SUBJECT: ISSUANCE OF AMENDMENT NOS. 172 AND 51 TO FACILITY OPERATING LICENSES  
DPR-66 AND NPF-73, IN RESPONSE TO CHANGE REQUEST NOS. 208/74,  
REDUCED THERMAL DESIGN FLOW (TAC NOS. M85819 AND M85820)

BEAVER VALLEY POWER STATION, UNIT NO. 1

BEAVER VALLEY POWER STATION, UNIT 2

SAFETY EVALUATION BY THE OFFICE OF NUCLEAR REACTOR REGULATION  
RELATED TO AMENDMENT NO. 172 TO FACILITY OPERATING LICENSE NO. DPR-66  
AMENDMENT NO. 51 TO FACILITY OPERATING LICENSE NO. NPF-73

FIGURE 2.1-1

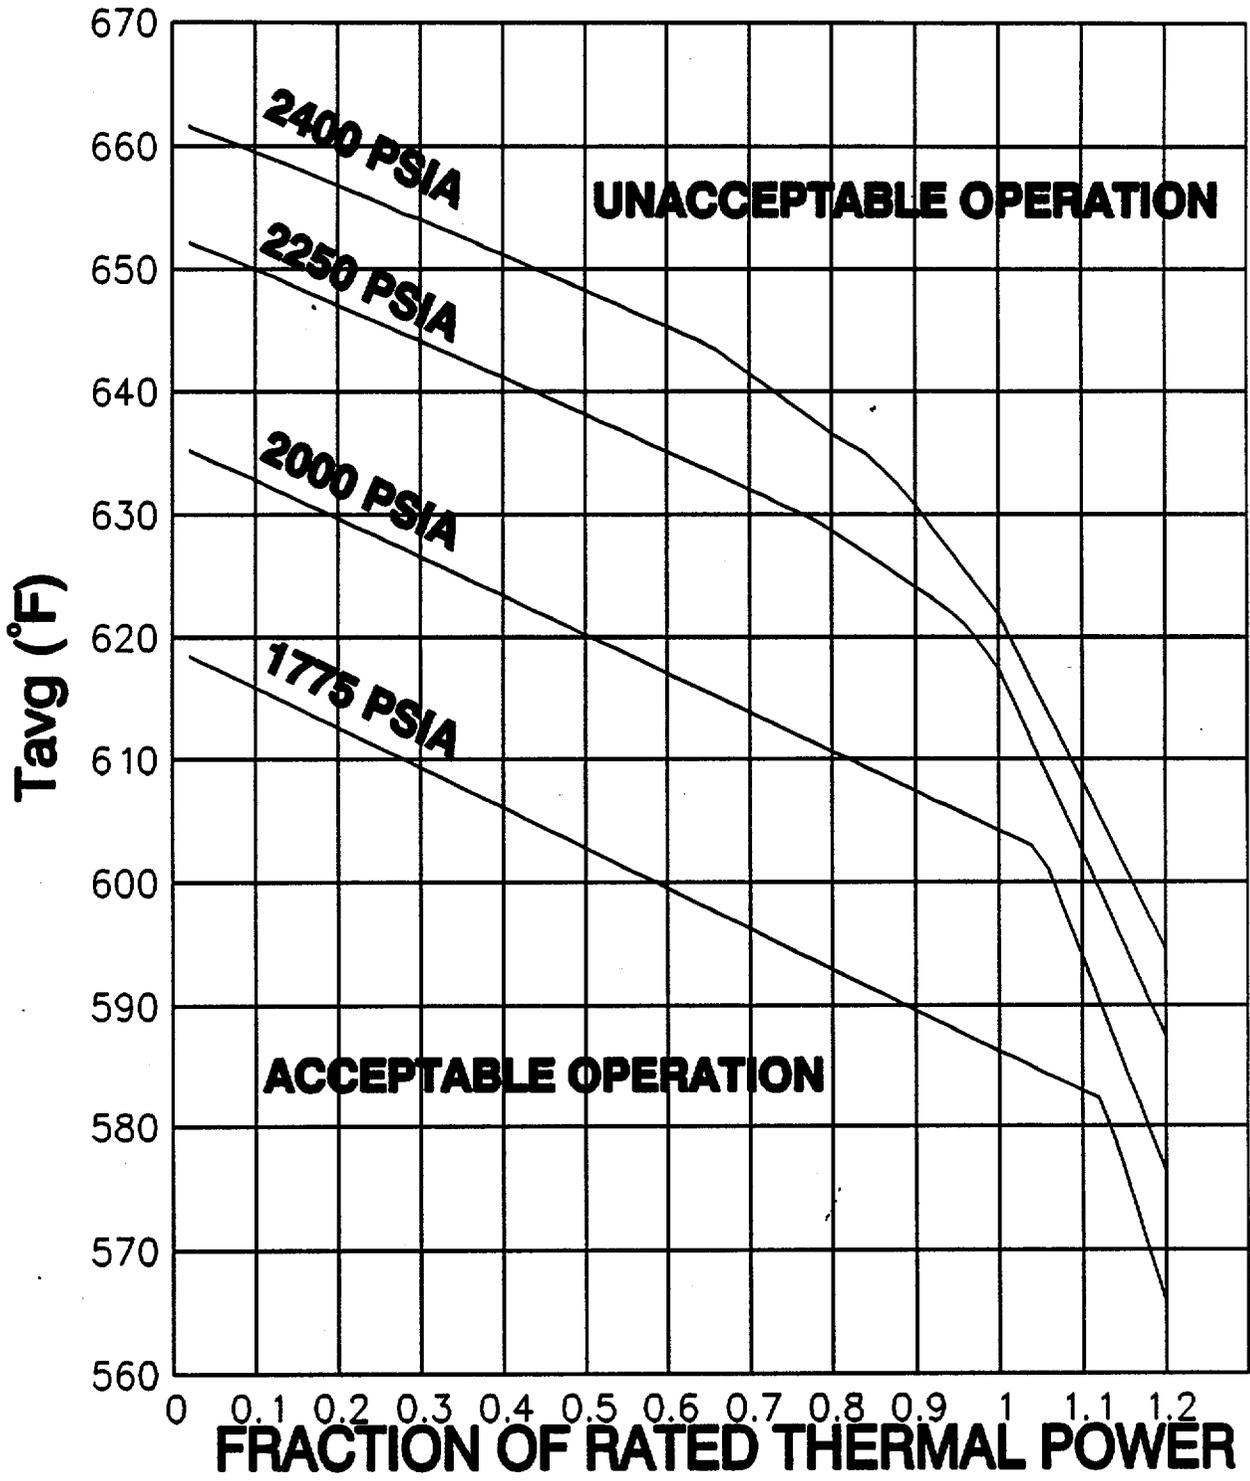
To support the proposed reduction in flow, the exit boiling portion of the core thermal limits illustrated in Figure 2.1-1 required revision for Units 1 and 2. Additionally, Figures 2.1-2 and 2.1-3 (and all references to them) have been deleted for Unit 1. These figures, which provide core thermal limits for two-loop operation, are extraneous because plant operation with less than three loops is not permitted under the current license. Similarly, the limits pertaining to two-loop operation in Table 3.2-1 for Unit 1 have been deleted. The Unit 2 TS do not address two-loop operation.

With regard to the impact of the proposed flow reduction on core thermal limits, the licensee's evaluation indicates that the DNBR-limited segment of each thermal limit line in the current TS remains bounding. As noted above, the retained DNBR margin is large enough to accommodate the penalty assessed against it due to flow reduction. The vessel exit boiling segment of each thermal limit line was revised, however, to reflect the 1.5 percent reduction in flow. The effect is less than a 1°F decrease in exit boiling limits. Additionally, the licensee confirmed that the current OT delta-T and OP delta-T setpoint equations continue to provide protection for the revised core thermal limits.
